# KENWOOD

ASB-1017

## Service Bulletin

**Subject:** TS-950 Noise with Sub-Band Noise Blanker ON  
1993

**X48-3060-00  
Component Side View**

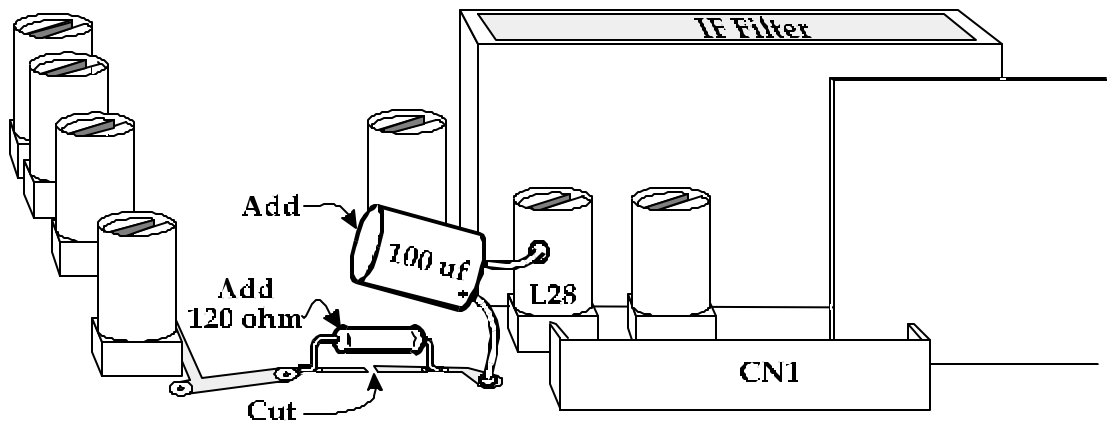
Noise is generated when NB1 is switched on for the sub-receiver.

Switching noise from the noise-blanker gate enters the AF amplifier via the +15 V line causing the noise.

1. Cut the pattern of the 15 V line on the IF Unit (X48-3060-00) component side, near Q34's emitter and add the 120 ohm resistor as shown in the accompanying diagram.
2. Add the electrolytic capacitor as shown in the diagram. Quickly solder the negative lead to the metal shield of L28.
